Project Name:	Dirigo Plaza	Project ID:	#2016-073
Address:	1190 Brighton Avenue, Westbrook, Maine	CBL:	264-A-002
Applicant:	Dirigo Center Developers, LLC. (previously J & J Gove Development Group)		
Planner:	Barbara Barhydt, Development Review Services Manager

**Memorandum
 Planning and Urban Development Department
 Planning Division**

To: Elizabeth Boepple, Chair, and Members of the Portland Planning Board
From: Barbara Barhydt, Development Review Services Manager
Date: October 14, 2016
Re: Dirigo Plaza (Main Street Westbrook, 1190 Brighton Avenue, Dirigo Center Developers, LLC, Applicant
Project #: 2016-073 **CBL:** 264-A002
Hearing Date: October 18, 2016

Re: Site Plan and Subdivision Application, Dirigo Plaza; Dirigo Center Developers, LLC; Applicant's Narrative Response to the City of Portland's Off-Site Traffic Mitigation Comments

Rand Road at I-95 Exit 47 Ramp Conceptual Improvement Plan

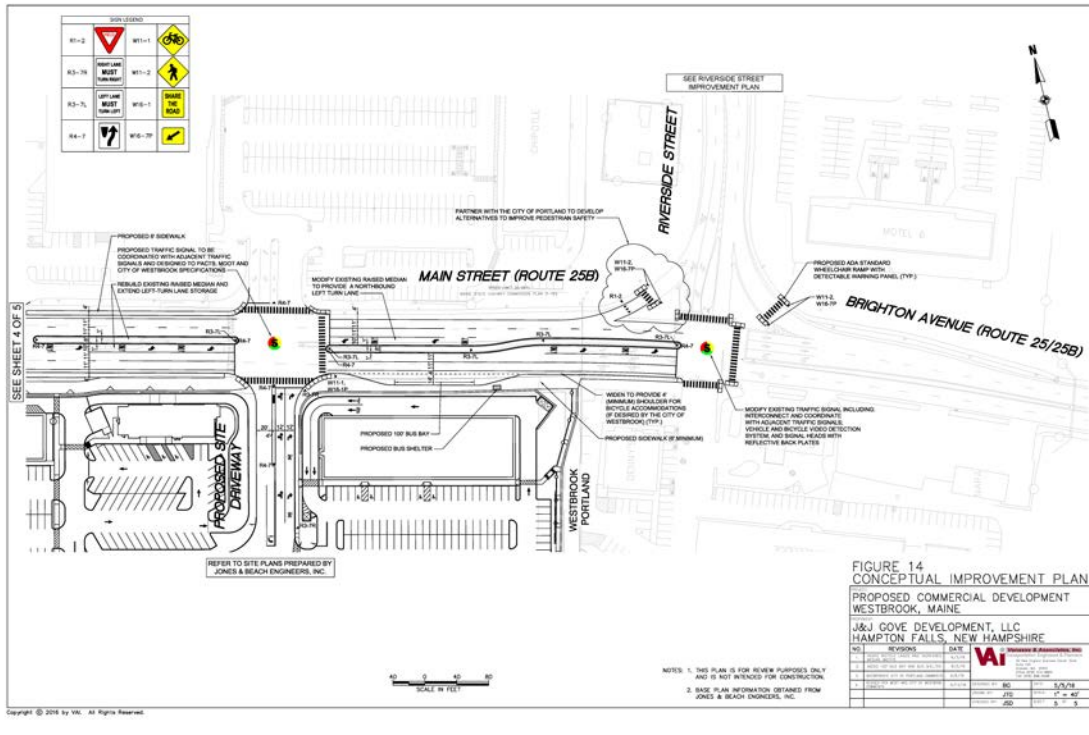
Widen I-95 ramp to provide a second left-turn lane to the Westbrook Arterial.
Widen Rand Road to accept the dual-left turn lanes.

Upgrade traffic signal equipment, design and implement an optimal traffic signal timing, phasing and coordination plan. Ensure there is a hardwire or wireless interconnect to the adjacent intersection at the site entrance at Westbrook Arterial.

Portland Staff Comment: City staff strongly prefers hardwire interconnects where they are feasible to be provided. The applicant in its memo to the Board and its comments on the draft TMP agrees to implement the hardwire interconnect "to

Figure 14 Conceptual Improvement Plan, Brighton-Riverside Intersection, Sheet 4 of 5

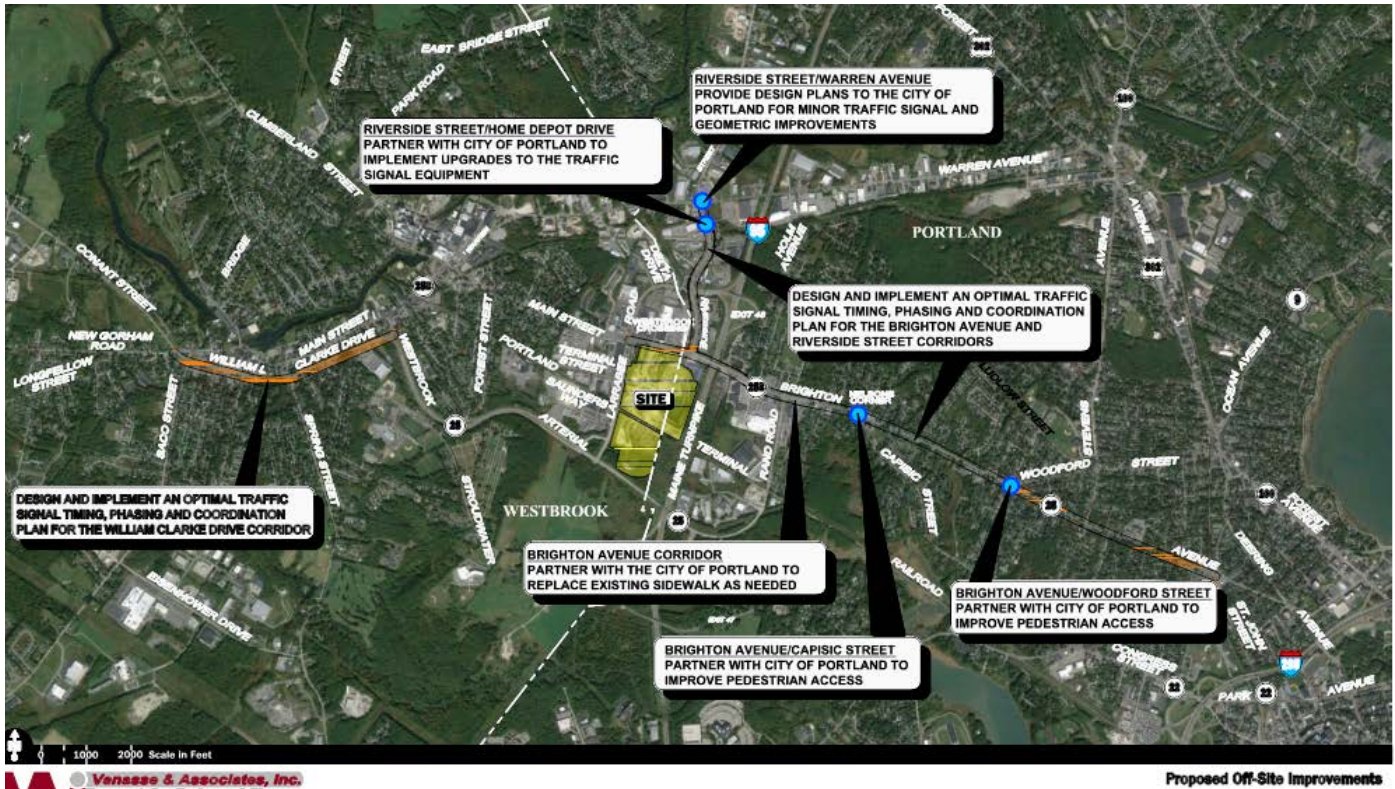
Portland Staff Comment: In its memo to the Board and its comments on the draft TMP, the applicant has agreed to updated signal heads with reflective back plates (as proposed on the applicant's Conceptual Improvement Plan, Sheet 4 of 5), and updated thermal (not video) detection to meet the City's standard.

FIGURE 14
CONCEPTUAL IMPROVEMENT PLAN

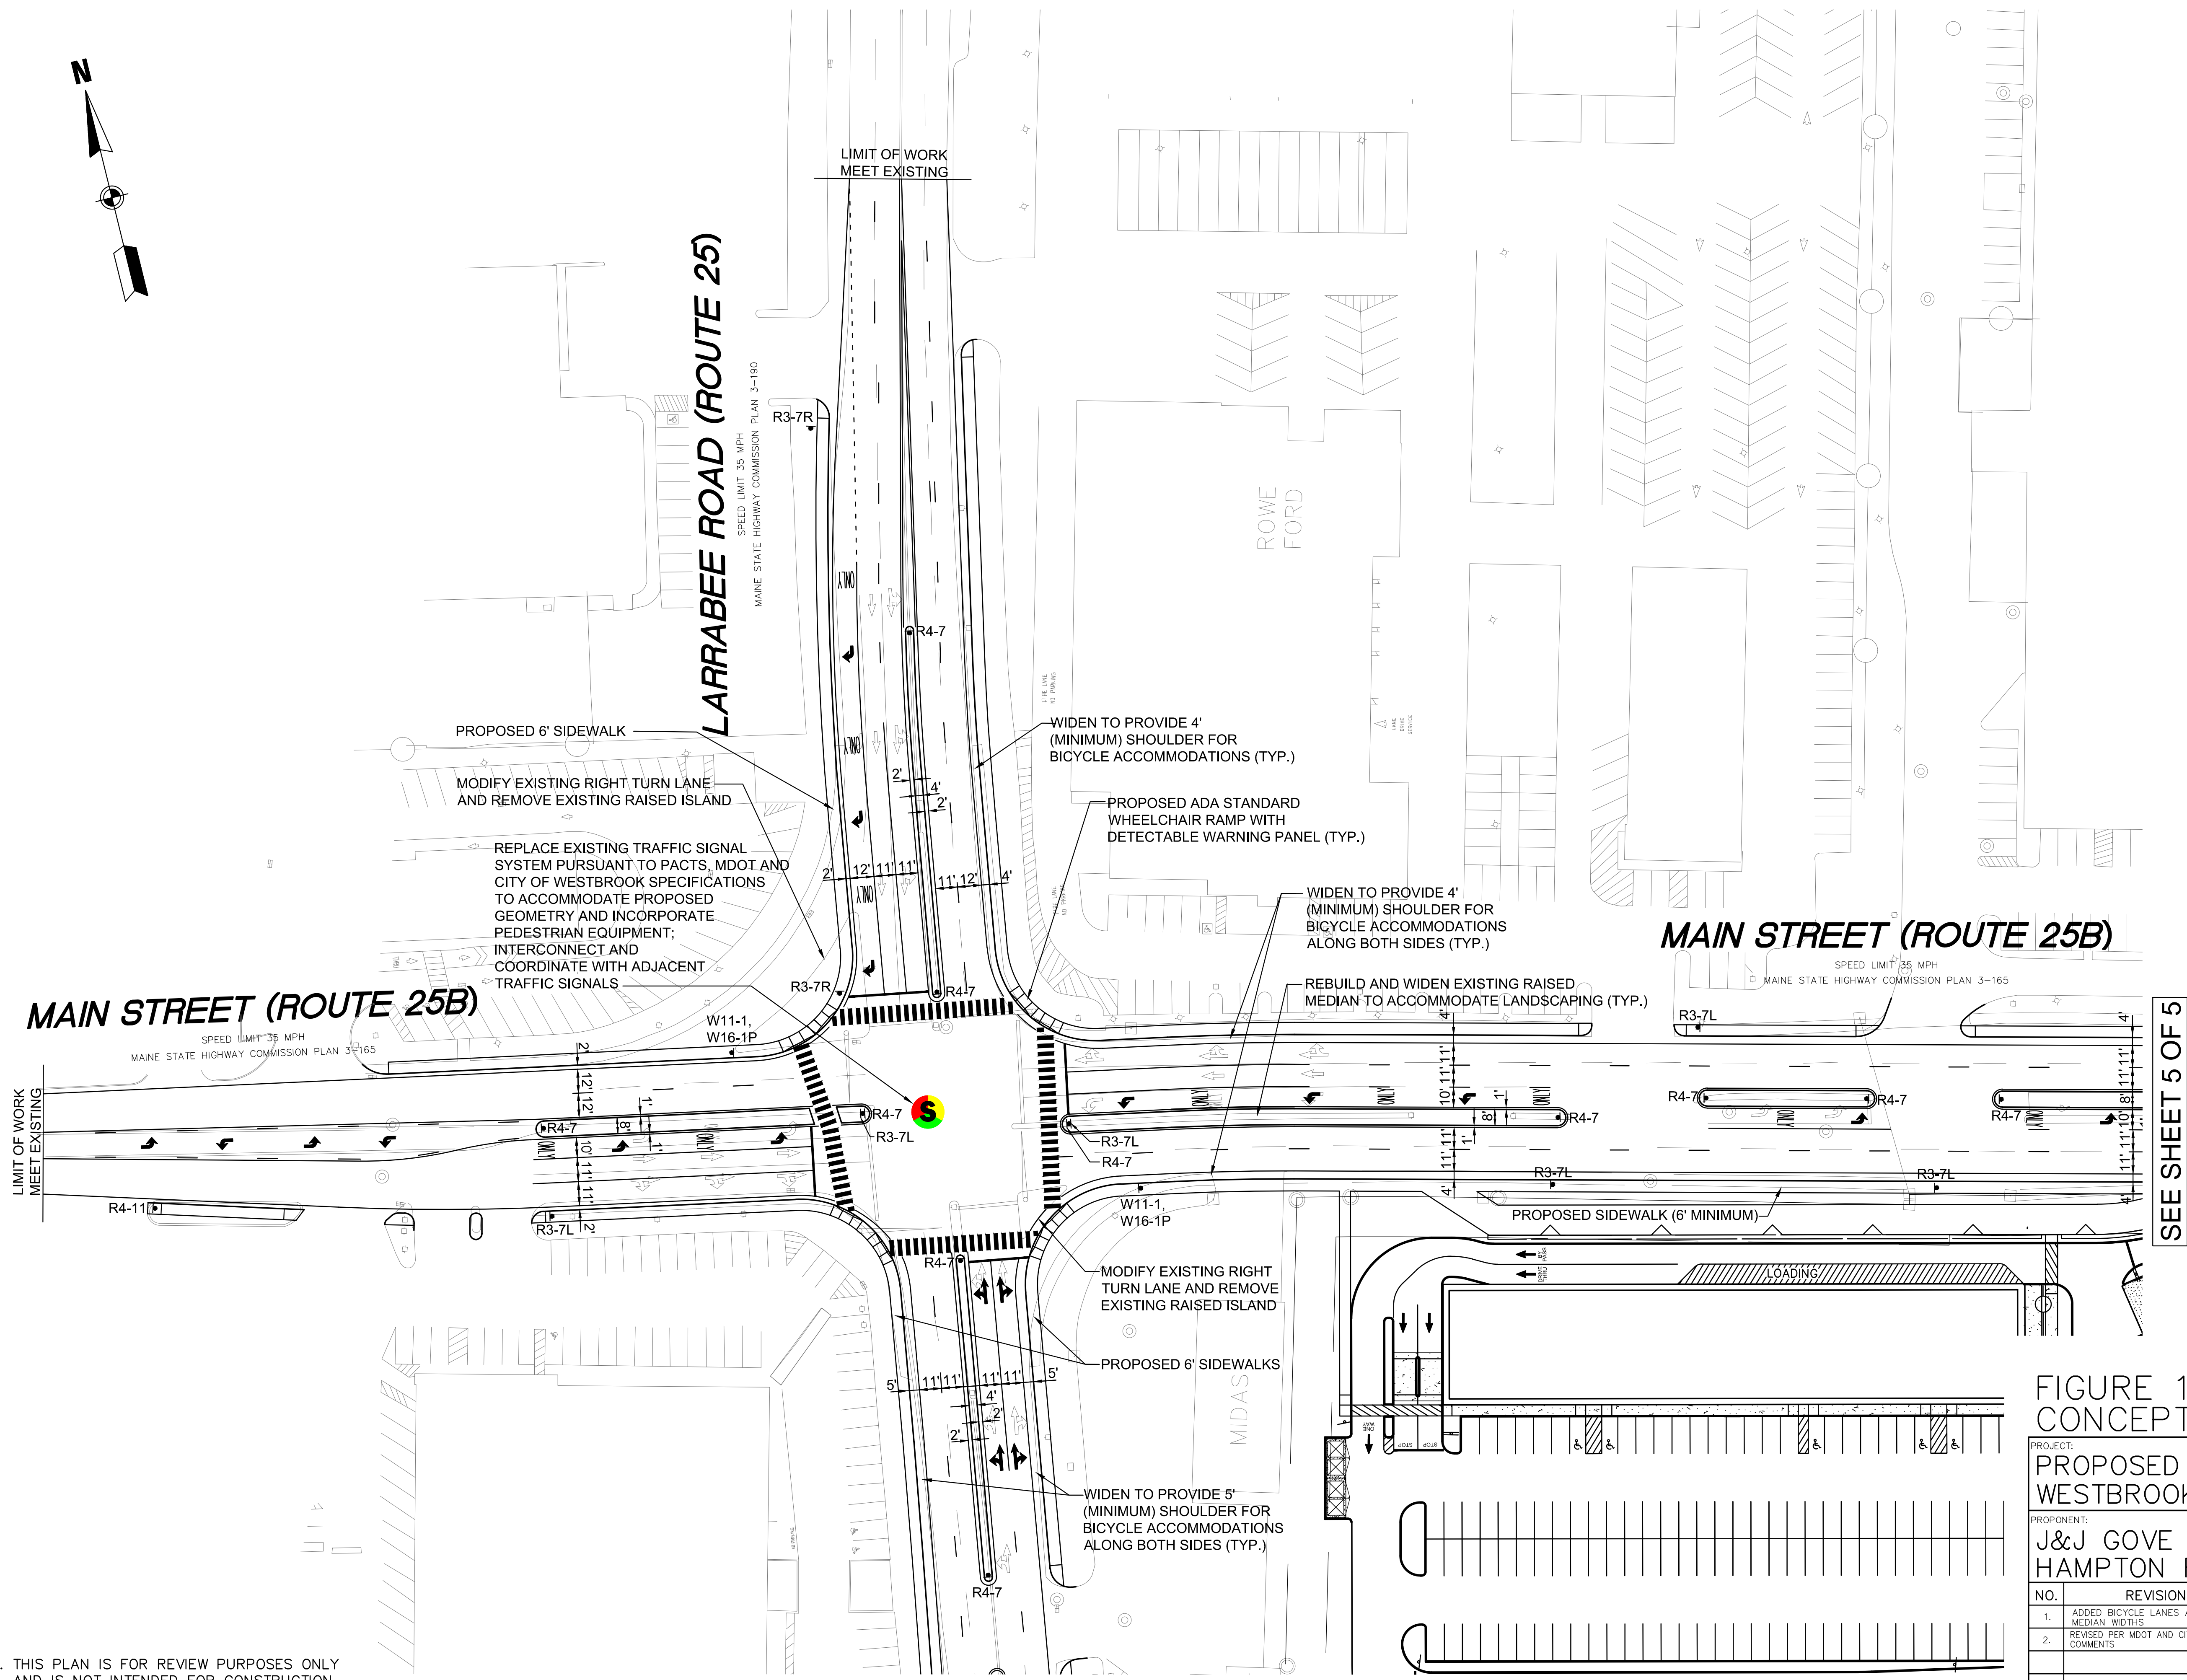
Portland Staff Note: The TMP should require updated signal heads with reflective back plates (as proposed on the applicant's Conceptual Improvement Plan, Sheet 4 of 5), and updated thermal (not video) detection to the City's standard.
